Zoning Board of Appeals Agenda
September 19, 2024

RE: Justification for (2) variances: Dimensional variance for sign setback and parking reduction

ZONING BOARD OF APPEALS STAFF REPORT
REDUCTION IN THE REQUIRED NUMBER OF PARKING SPACES
REDUCTION IN THE SETBACK OF A NEW MONUMENT SIGN
WEXFORD COMMUNITY CREDIT UNION
1021 N. MITCHELL STREET
CADILLAC, MICHIGAN 49601

Site Plan – Building & Site Improvements

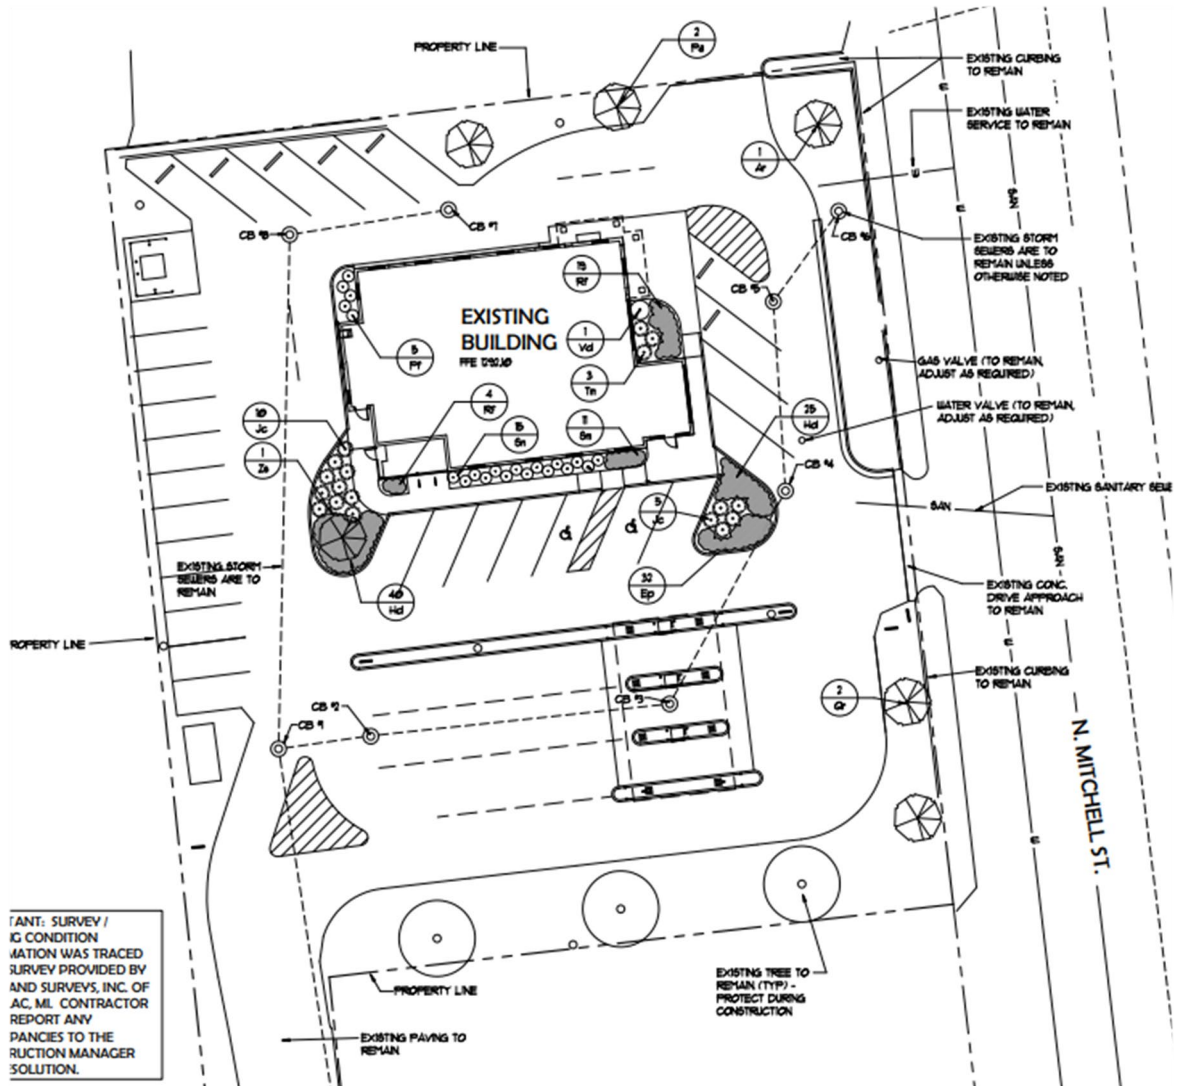
The Credit Union is proposing improvements to the existing building and site, enhancing customer service and safety. Of note is the planned separation of pedestrian traffic from the vehicular (drive-thru) stations. The current drive-thru station lanes are attached to the south side of the Credit Union building. South of the drive-thru area is customer and employee parking. Pedestrians traveling to and from parked vehicles must cross the path of vehicles exiting the drive-through lanes. The planned improvements separate the drive-thru stations from the building, relocating them to the southern portion of the site, replacing the area now used for parking and pedestrian travel. Essentially, the areas will be reversed. The stations include a new canopy and vehicular bypass lane. Other planned exterior improvements include a new main building entry, an outdoor seating area, new dumpster pad area, other parking improvements, an electronic monument sign to replace the existing pole sign along Mitchell Street, pedestrian walkway enhancements, bicycle station, and site landscaping. (Site Plan follows.)

Existing Conflict - Drive-Thru Stations and Pedestrians Travel

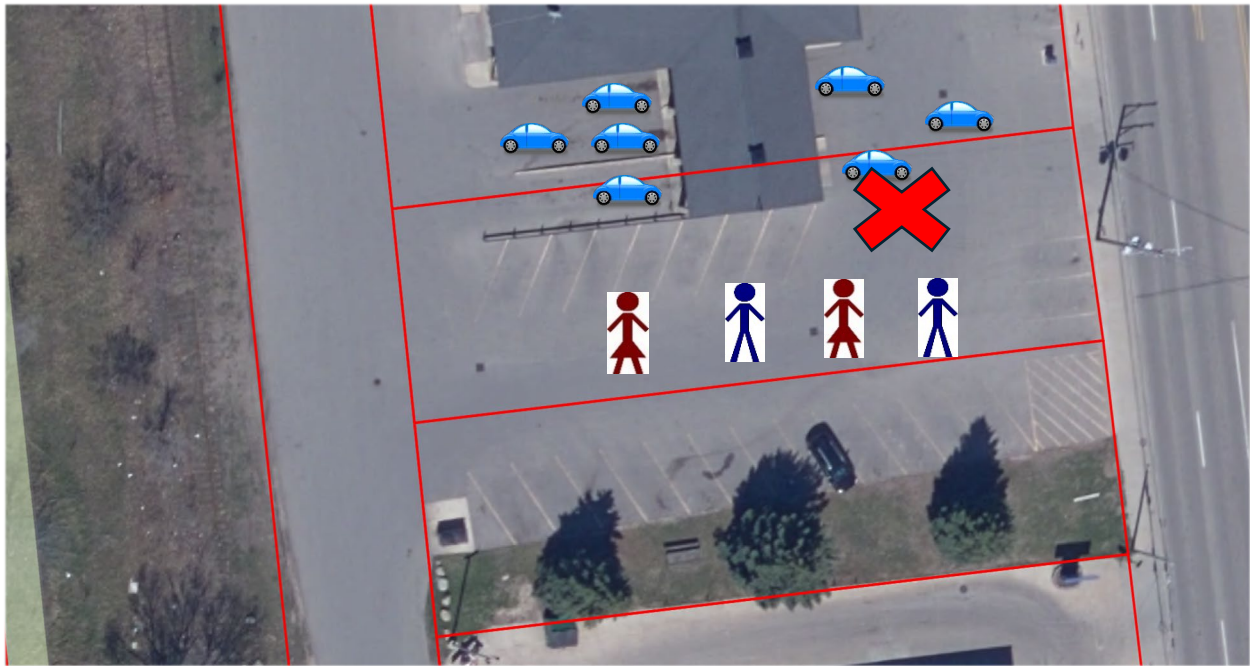
The above graphic depicts existing client and employee parking found on the south side of the site. The present drive-thru stations are attached to the south side of the Credit Union building, between the building and parking. The design creates a potential for conflict between exiting vehicles and pedestrians moving to and from the parking area and building.

Relocated Drive-Thru Stations and Parking

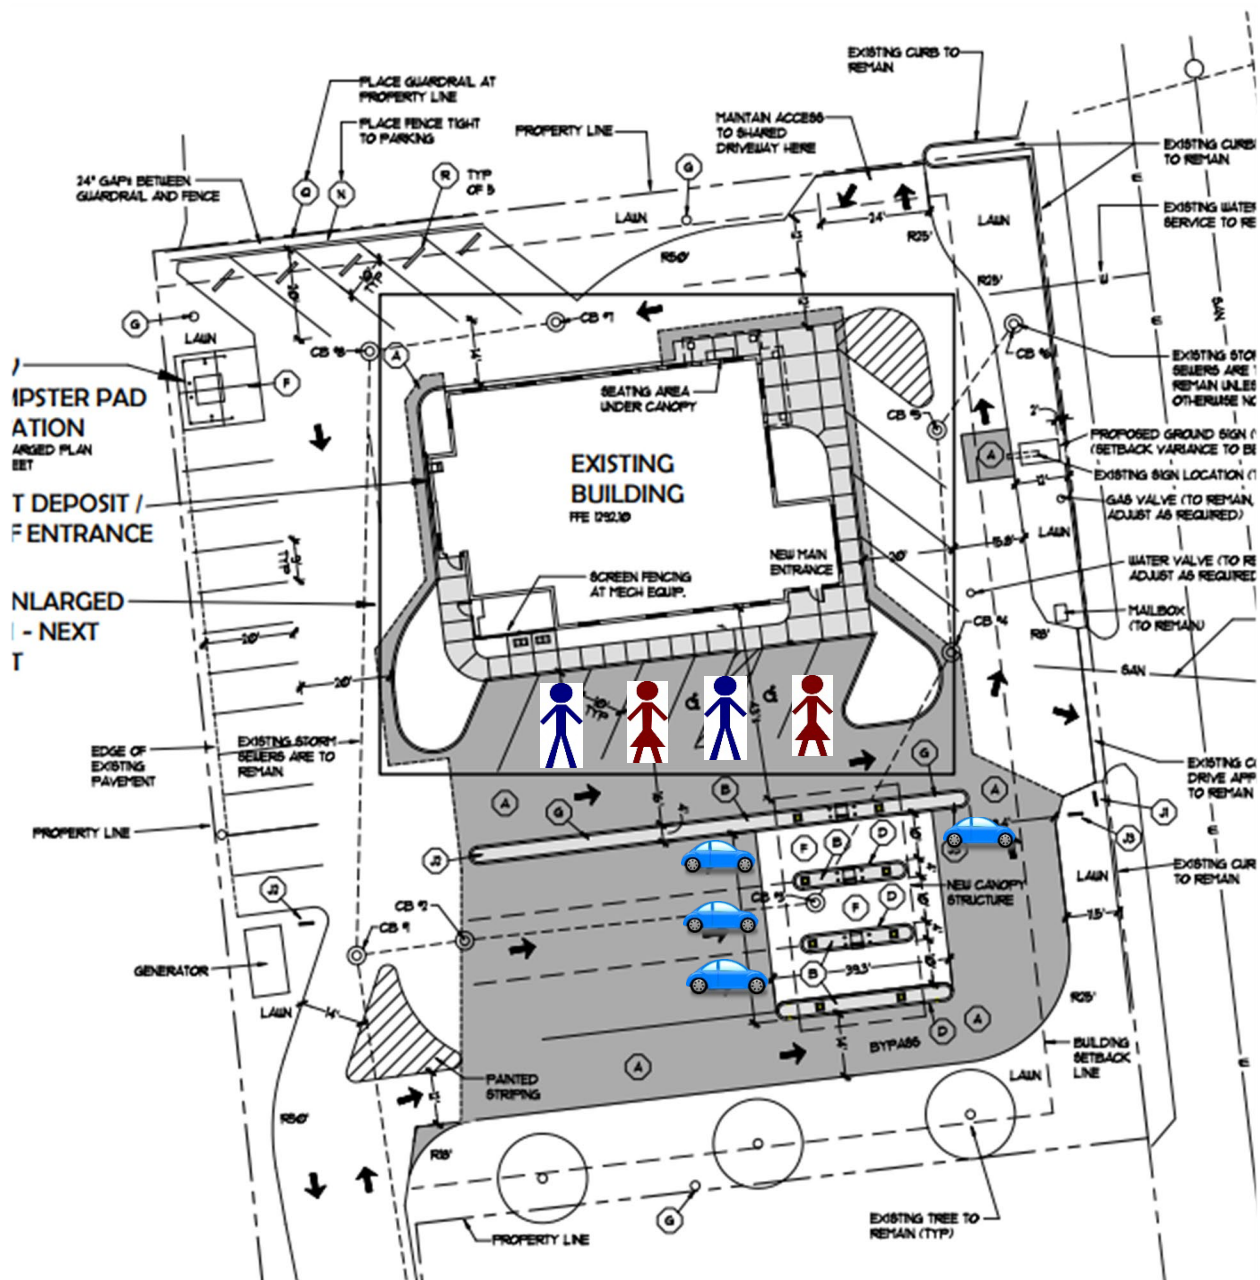
As noted on the following graphic, the redesign of the site resolves the conflict. The drive-thru stations will be detached from the building and relocated to the extreme south. Parking will be relocated near the building.

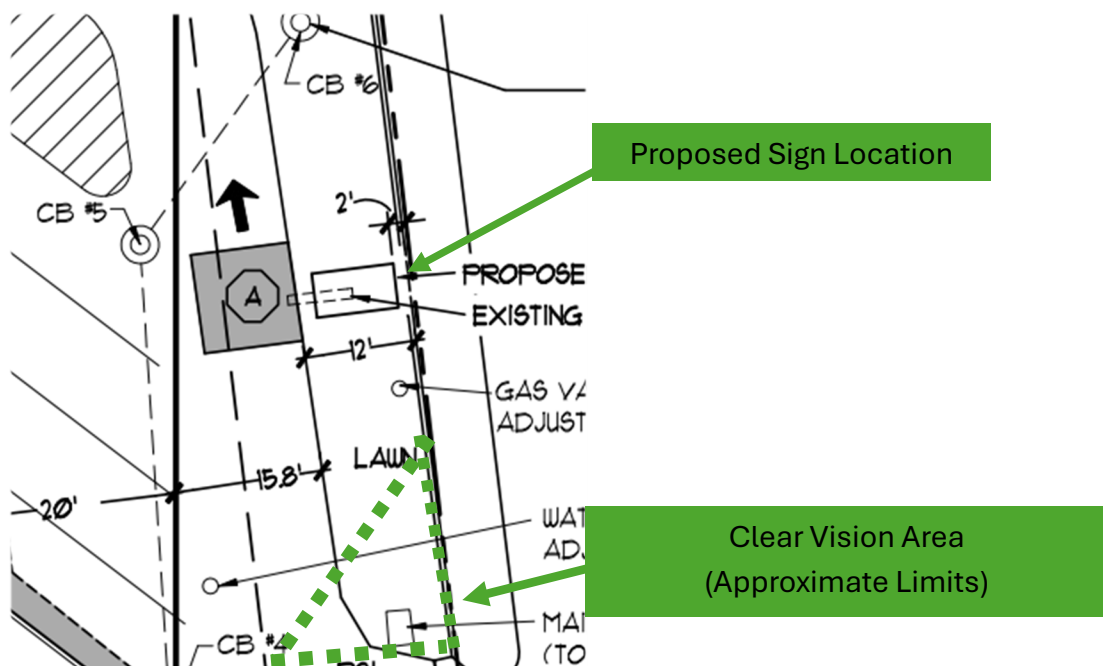
In the examination of the application, staff reviewed the sign location pursuant to its impact on clear vision requirements. Section 46-664(d)(1)k provides that signs having the potential to obstruct visual clearance by exceeding 30 inches in height shall not be permitted within the triangular area formed at the intersection of the traveled portion of any street, driveway or alley by a straight line drawn between them at a distance 25 feet from their point of intersection. Based on measurements using the applicant's site plan and the city's aerial maps, the proposed sign will be positioned outside the limits of the clear vision zone. (Refer to the following graphic.)

Staff are supportive of the new sign. However, based on Cadillac's seasonal weather involving the handling of snow, there is concern that a setback of two feet has the potential to result in damage to the monument sign during periods in which snow is removed from the abutting sidewalk and Mitchell Street. As proposed, the base of the sign would rest 2 feet from the sidewalk and roughly 8 feet from the street. According to the City Public Works Department, snow is removed from the sidewalk using a V-plow and blower. Snow is removed from Mitchell Street by larger equipment having the potential to propel snow significant distances depending on the speed of the truck, shape of the plow, moisture content of the snow, and other factors. It is also not uncommon for snow to bind with items such as ice and stones that have been dropped by passing vehicles. These may be propelled as well.

1. Reduce the sign size to achieve or approve compliance. It is the staff's opinion a minimum setback of at least 5 feet is desired for the purposes of improving clear vision site lines and reducing the potential for sign damage due to the removal of snow from the public right-of-way.
2. Relocate the sign to the planned lawn area along Mitchell Street to the north. The green area provides additional width possibly allowing for an increase in the sign's setback.

If a setback variance of any distance is granted, the staff recommends that the Zoning Board of Appeals impose a condition requiring the developer to waive any claims against the City for damage caused by snow removal in the public rights of way as the City does not want to expose itself to claims by virtue of having granted a variance. Furthermore, that the condition to be provided in a recorded instrument so that it is binding on future owners. The instrument to be prepared by the City Attorney.
